ADDENDUM NO. 4

Reference: Residential Halls Buildings 2 and 3
Weber State University – Ogden, Utah
DFCM Project No. 10176810 and 11008810

Subject: **Addendum No. 4**

SHEET REFERENCE
SB101

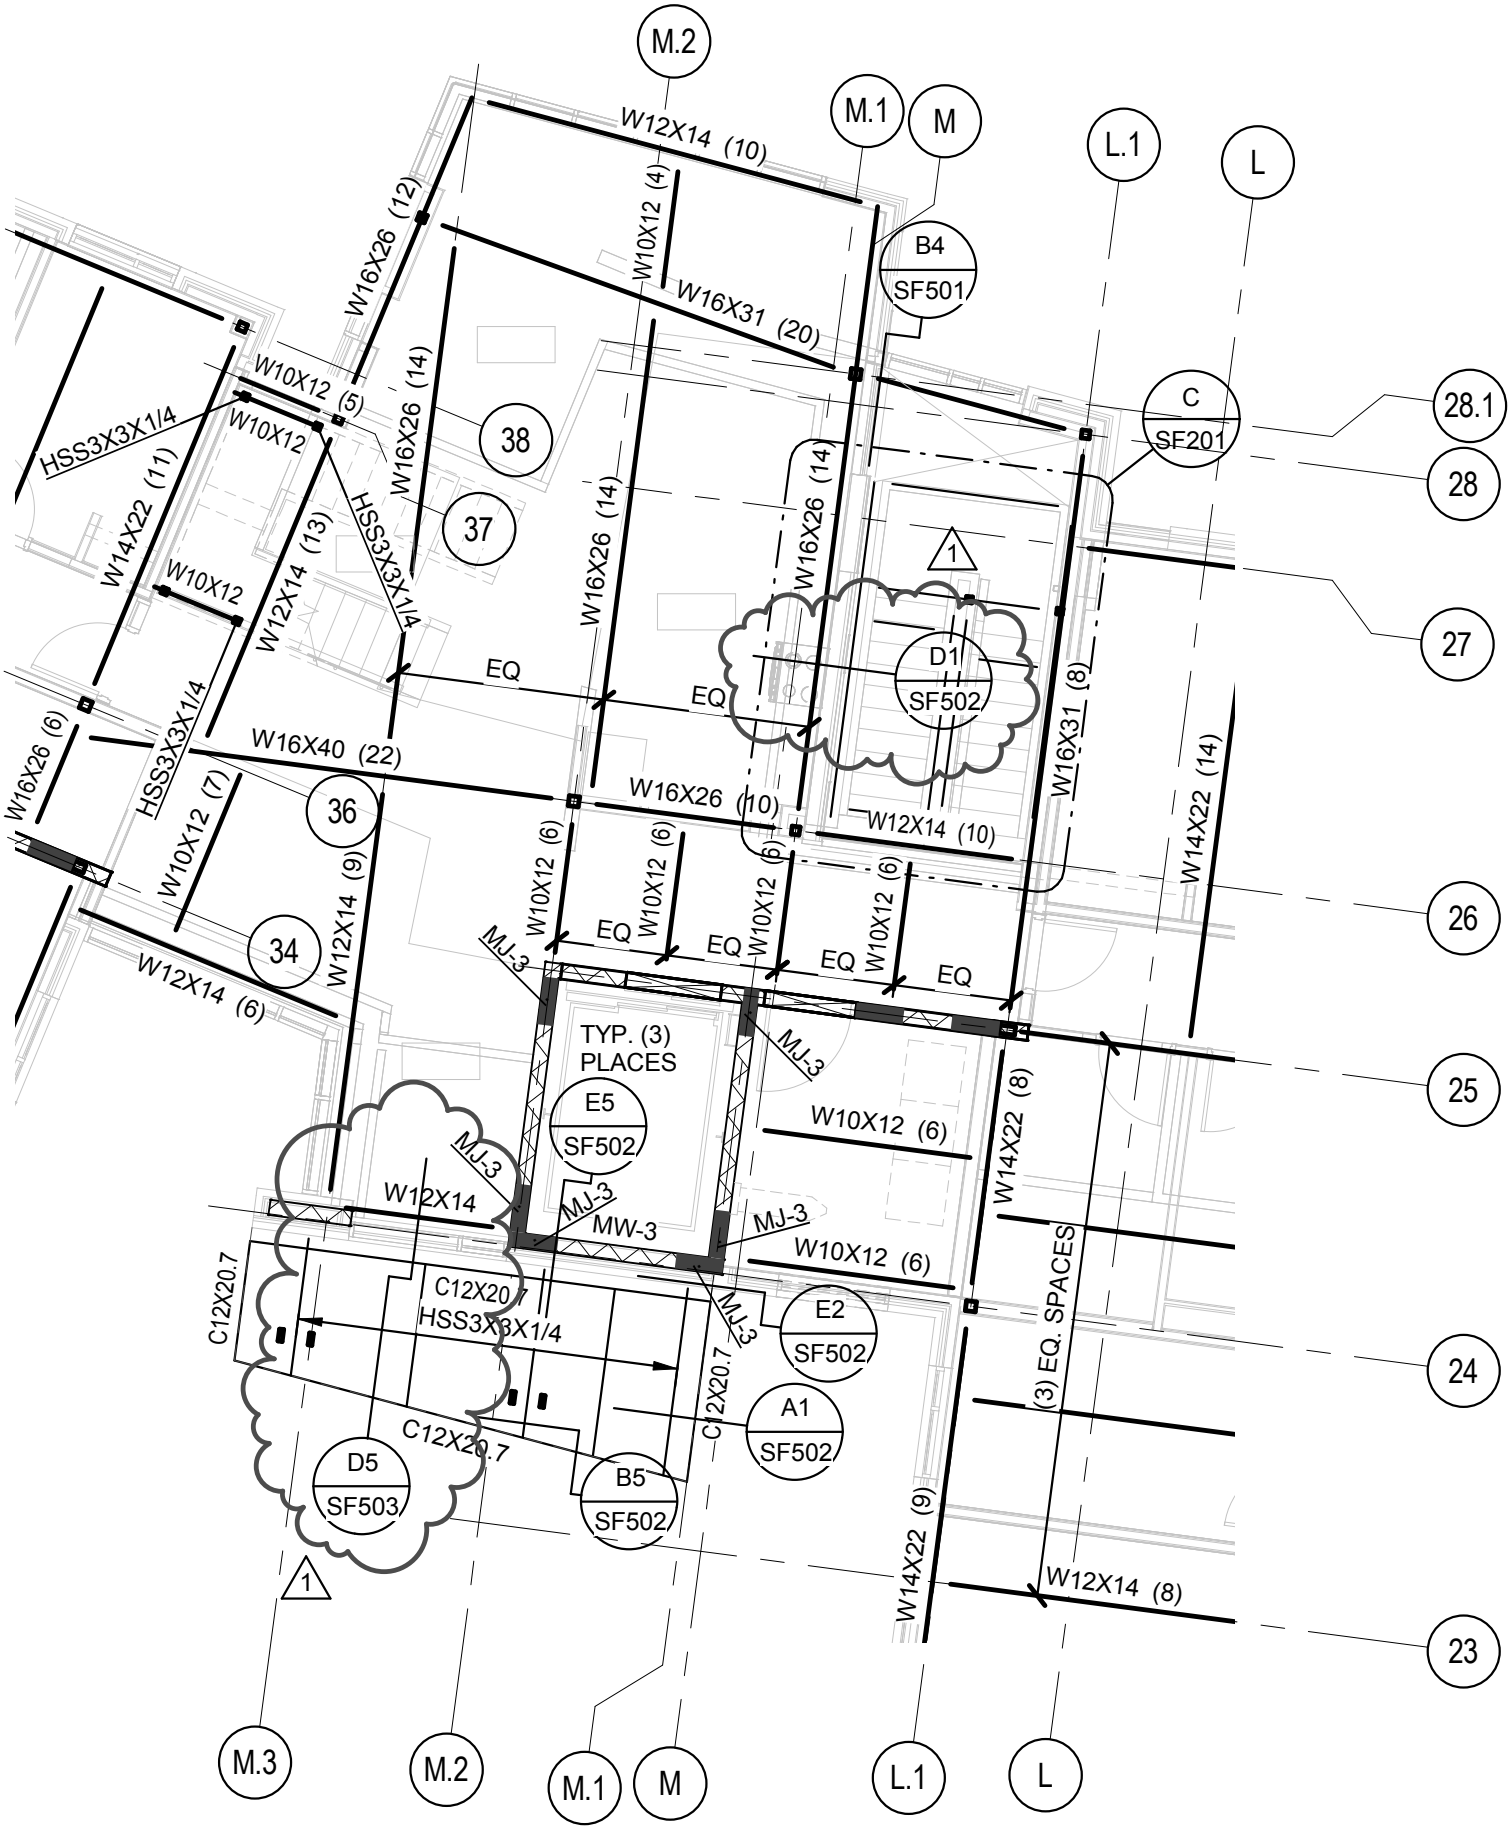
Sheet SB101
-The canopy column sizes have been changed. Please see the attached sheet AD04_S02.

LEVEL 2 CENTER STAIR PLAN

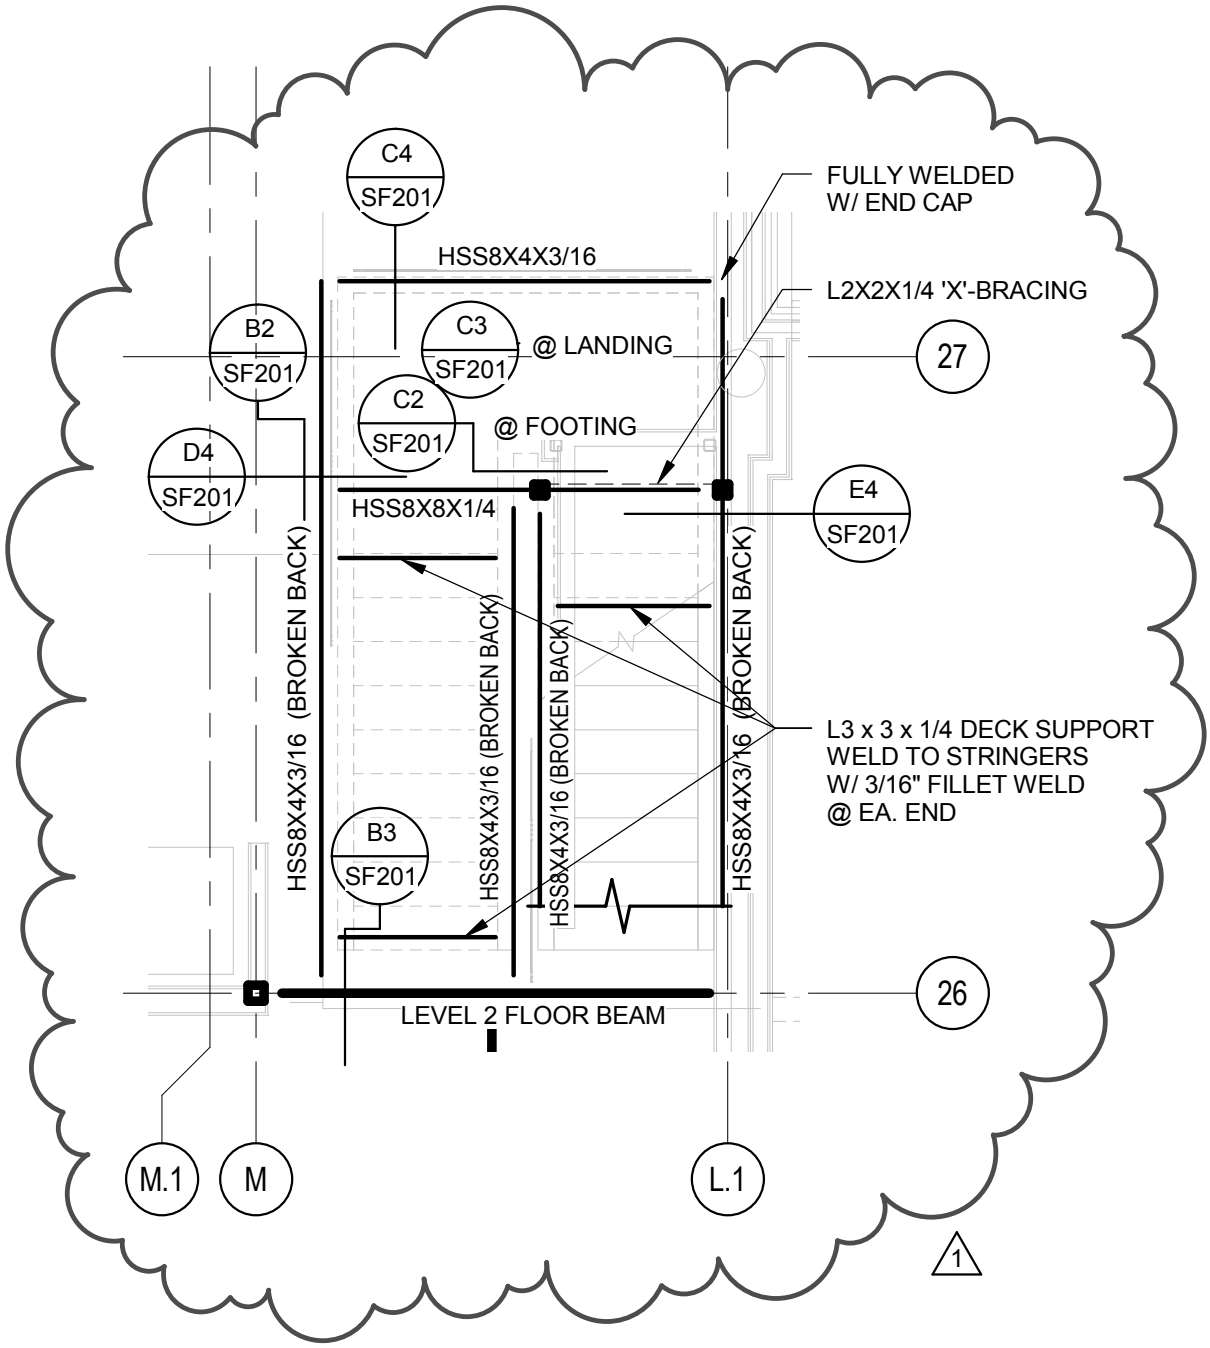
Sheet SF201
-C/SF201 has been revised. Please see the attached sheet AD04_S06.

SHEET REFERENCE
SF201

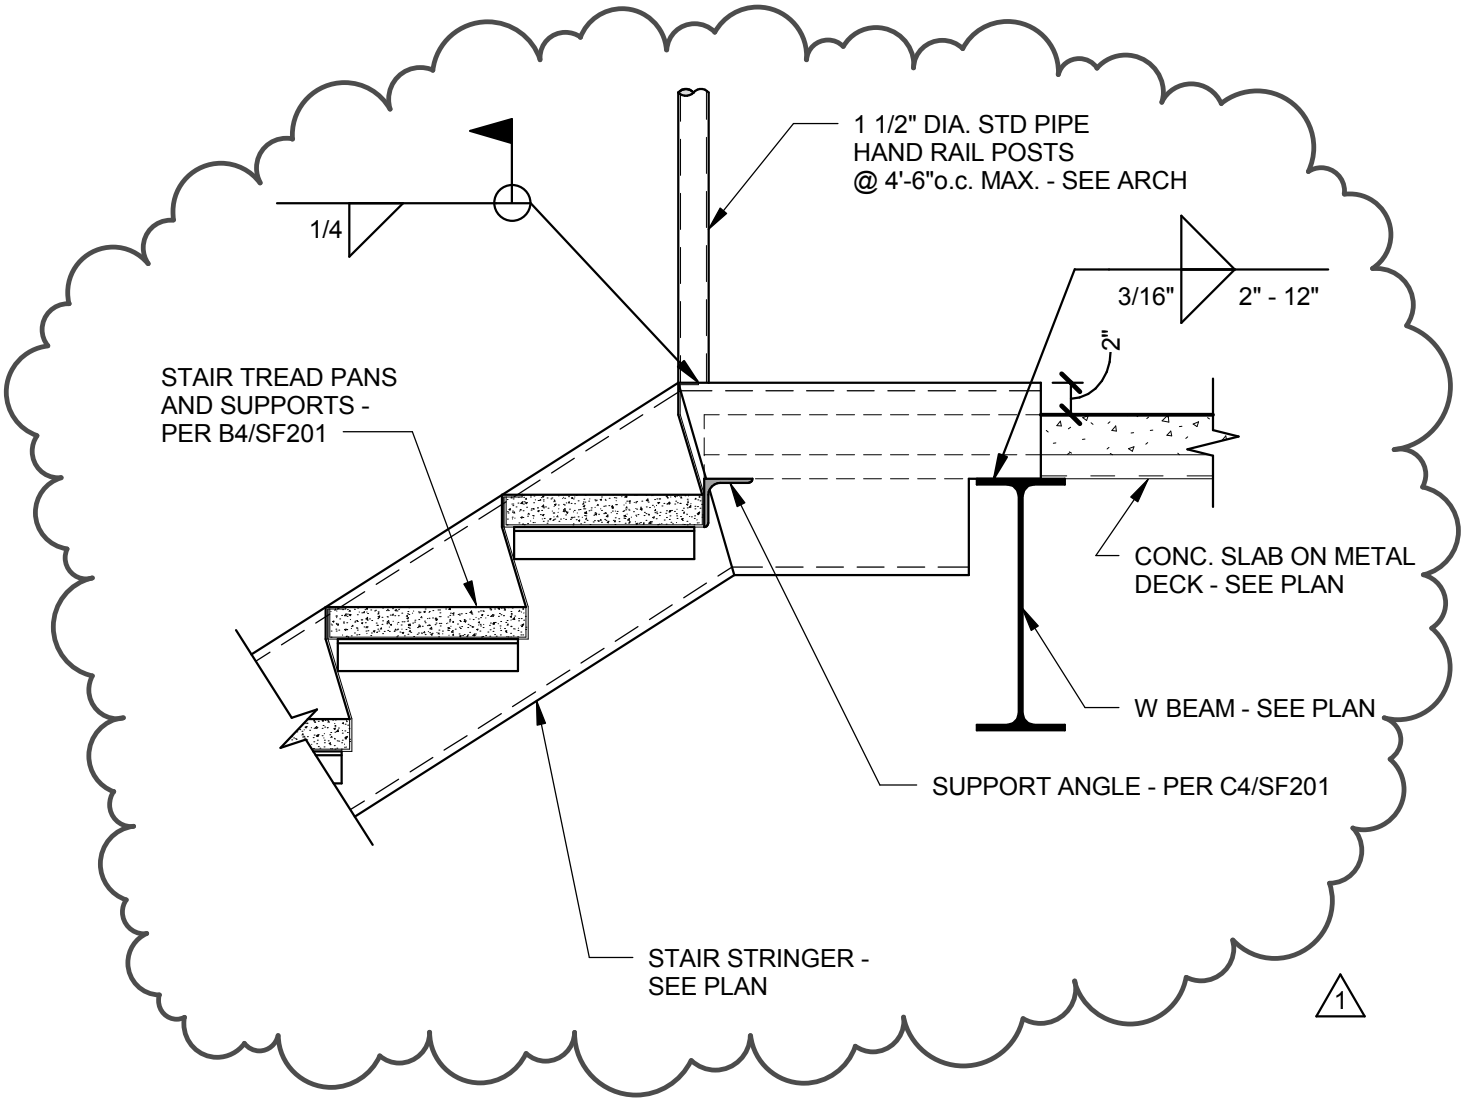
Sheet SF201
-Detail E5/SF201 is a new detail. Please see the attached sheet AD04_S07.

SHEET REFERENCE
SF502

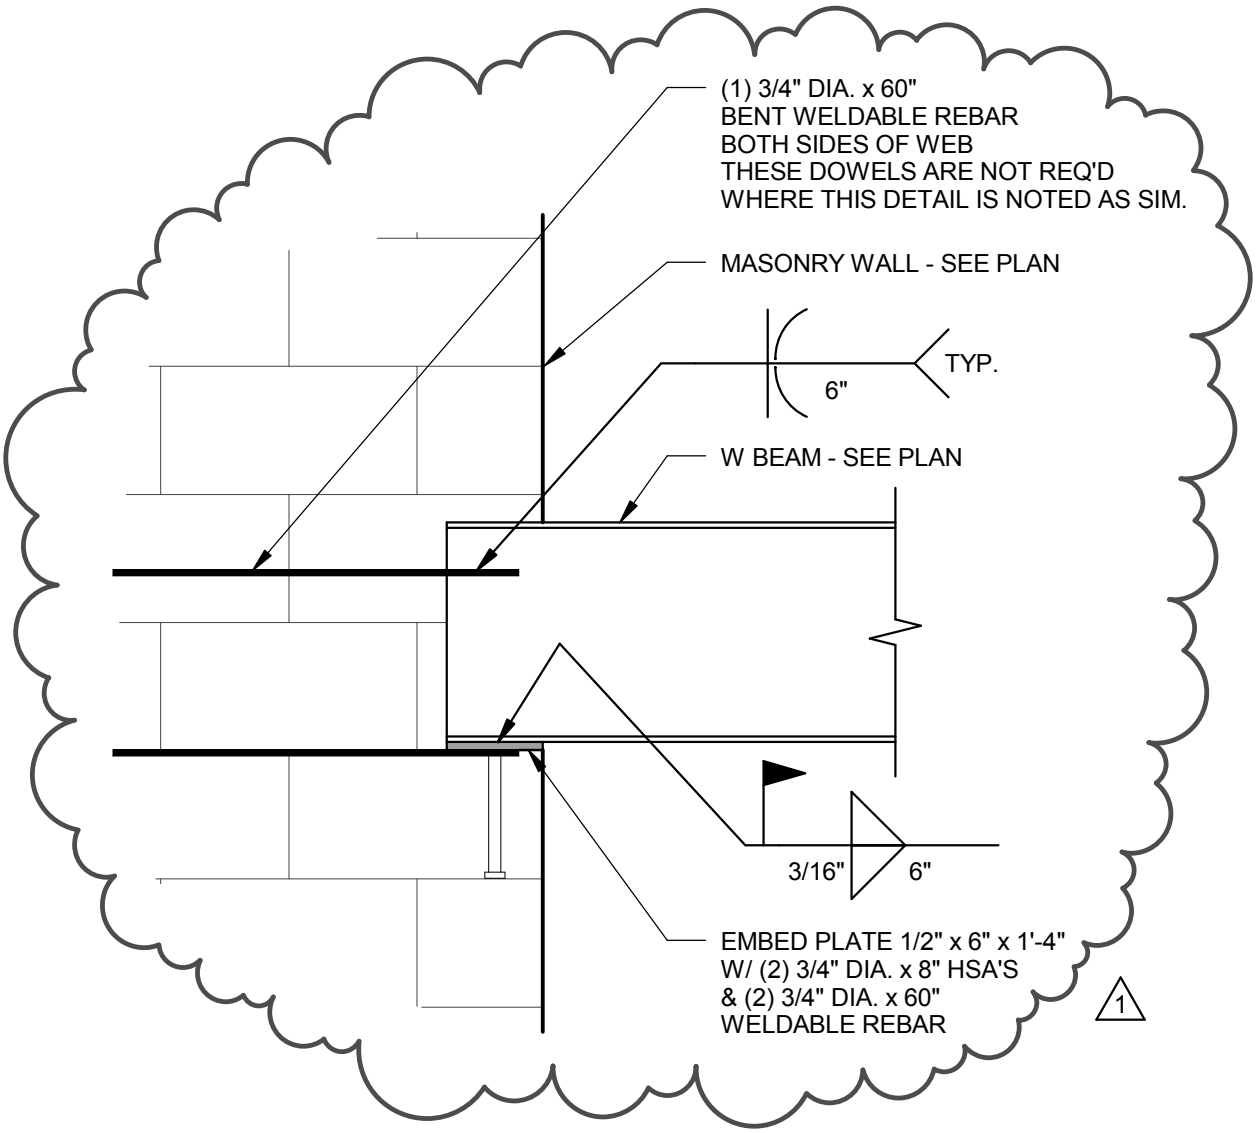
Sheet SF502
-Detail E2/SF502 has been revised. Please see the attached sheet AD04_S08.

SHEET REFERENCE
SF503

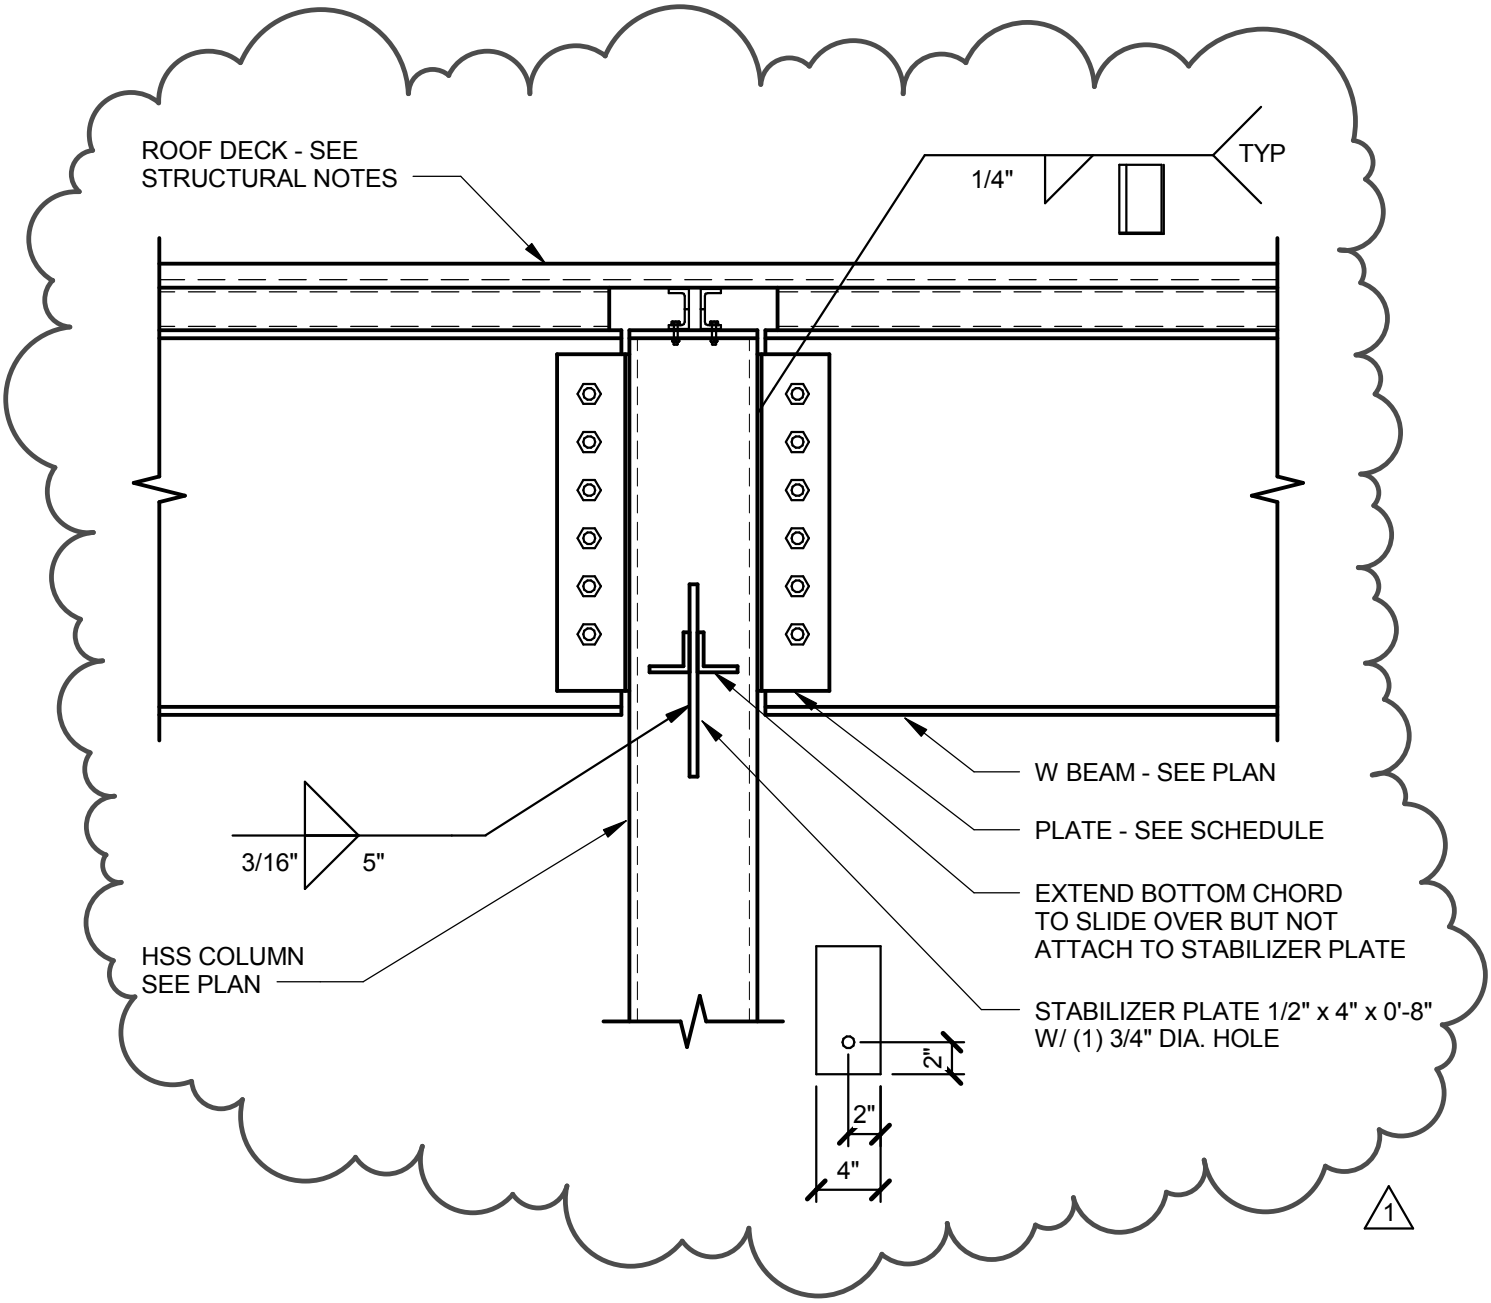
-Detail C2/SF503 has been revised. Please see the attached sheet AD04_S09.

SHEET REFERENCE
SF503

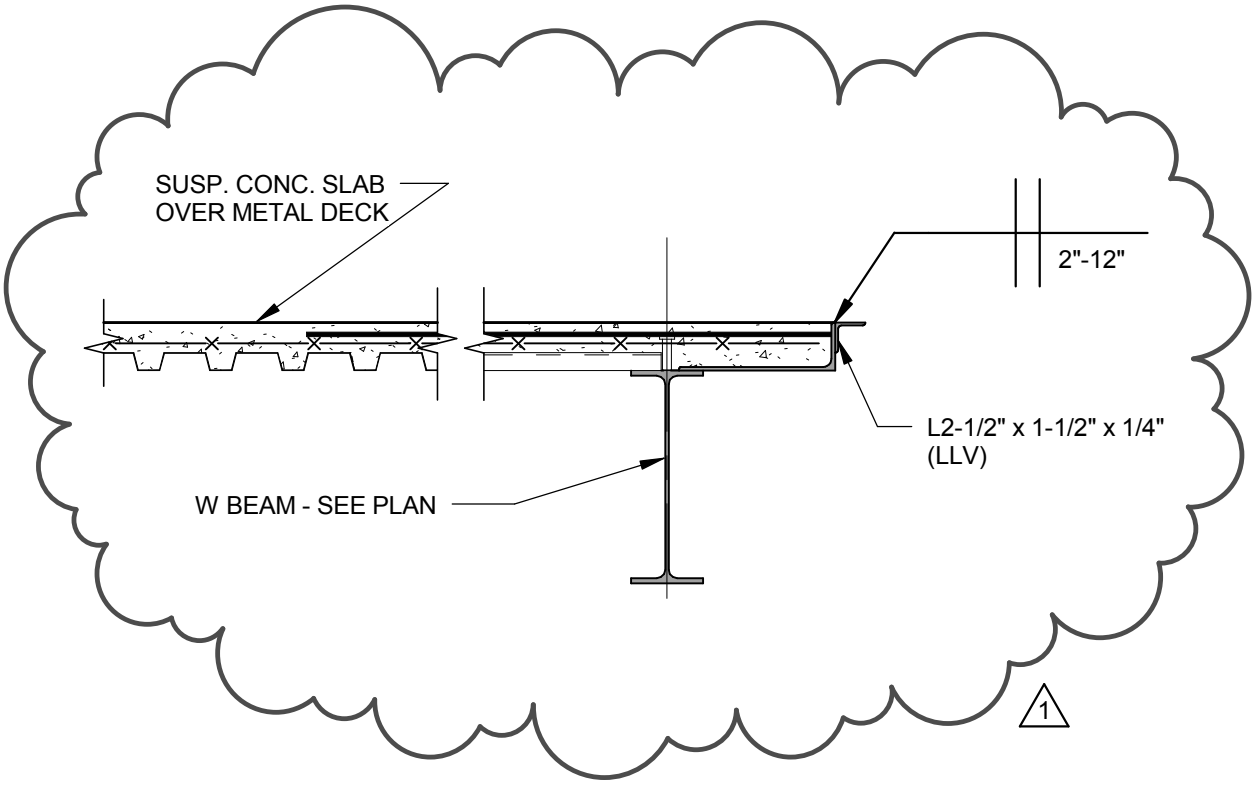
-Detail D5/SF503 is a new detail. Please see the attached sheet AD04_S10.
